ADDENDUM NO. 2

Date: 24 JUL 2024

SDG Project No.: 2315

Project Name: Troup County Pickleball Complex

SHEET:
ADD2-1A

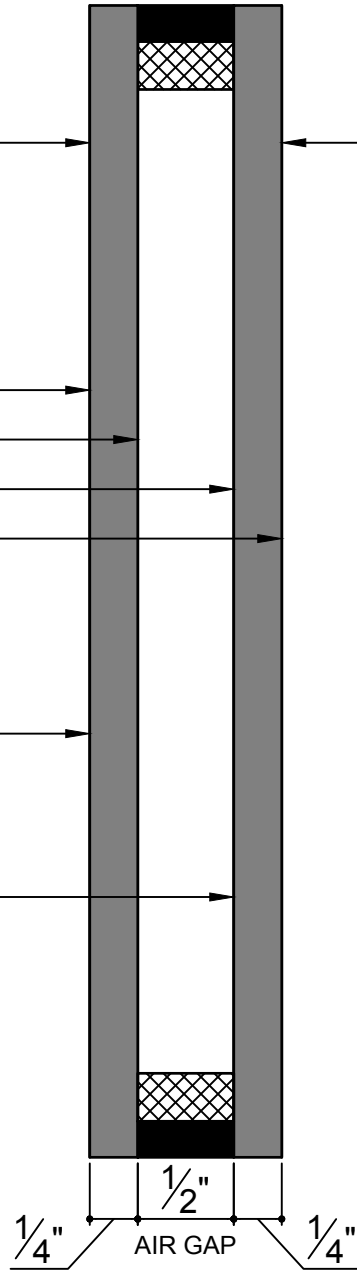
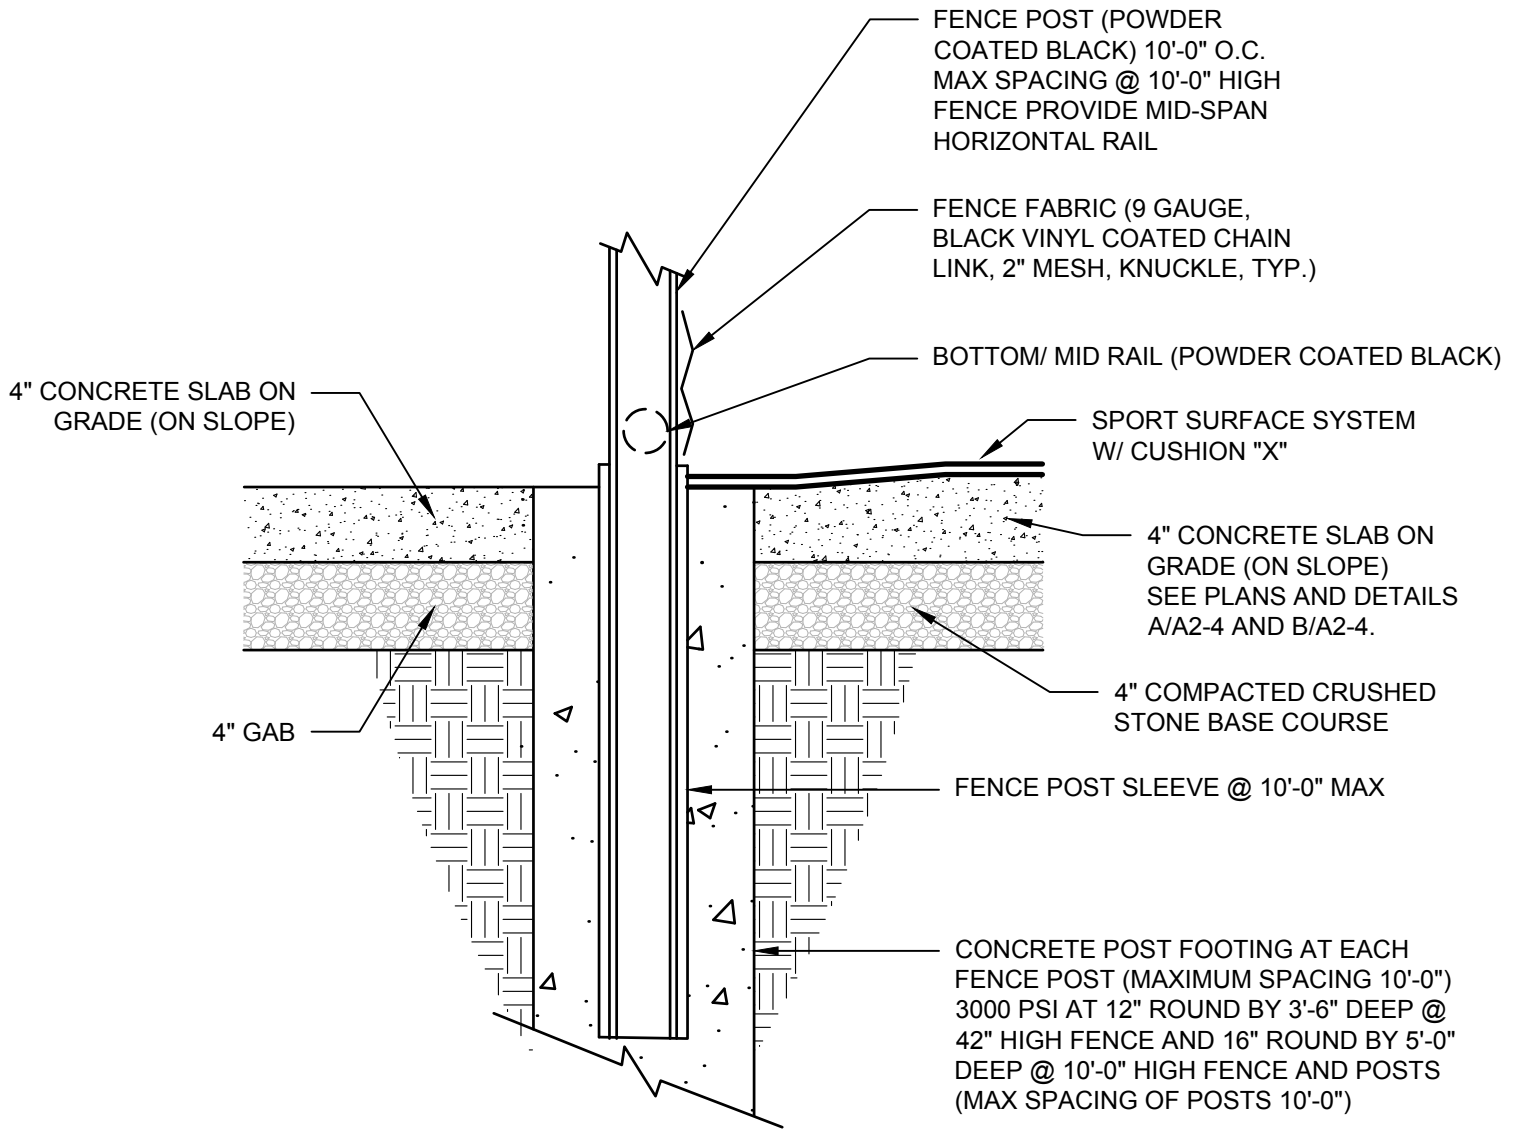
- A. Opaque glass design based on Vitro Glass TD-145 spandrel glass; see attached detail ADD2-1A, dated 24 JUL 2024. Storefront design based on Kawneer EnCORE Framing System; see attached supplementary Section 08401 - Aluminum Storefronts.

**** ALL OPAQUE GLASS IN THE PROJECT TO BE SPANDREL GLASS AS DETAILED BELOW ****

1. OPACIFIER TO BE LOCATED ON THE #4 SURFACE, DEPENDENT UPON OPACIFIER TYPE, GLASS SUBSTRATE TYPE, AND DESIGN APPLICATION.
2. RECOMMENDATIONS PERTAINING TO THE USE AND PLACEMENT OF INSULATION SHOULD BE SOLICITED FROM THE INSULATING GLASS SPANDREL UNIT MANUFACTURER.

OUTBOARD GLASS MUST
BE HEAT TREATED - HEAT
STRENGTHENED

INBOARD GLASS MUST
BE TEMPERED

DESIGN BASED ON VITRO GLASS (SPANDREL GLASS) TD-145
